Product Change Notification

■ Product list: Business430-17021_DF60 Series Crimping socket_Shape change of lock lever

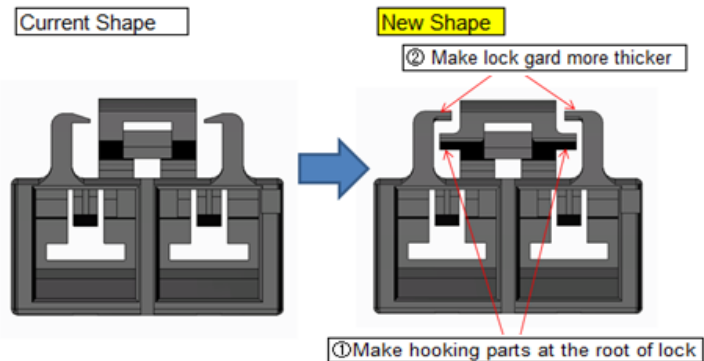
1	Products affected	DF60 Series crimping socket Please refer to the attached sheet on details.
2	Replacement products	Please refer to the attached sheet
3	Classification of change	Specification change
4	Description of change	<p>①This is to change the shape of lock lever. For 5 pin and 6 pin which originally have new shape, we will change product name only.</p>  <p>②This is to improve the strength of lock lever.</p> <p>These changes will not affect the performances of the products.</p>
5	Reason for change	For improving product performance(strength of lock lever)
6	Date of final reception of orders for the current product	August 31, 2018
7	Date of first reception of orders for the replacement	Already started selling
8	Date of final shipment of the current product	November 30, 2018
9	Date of your acknowledgement	By March 30, 2018
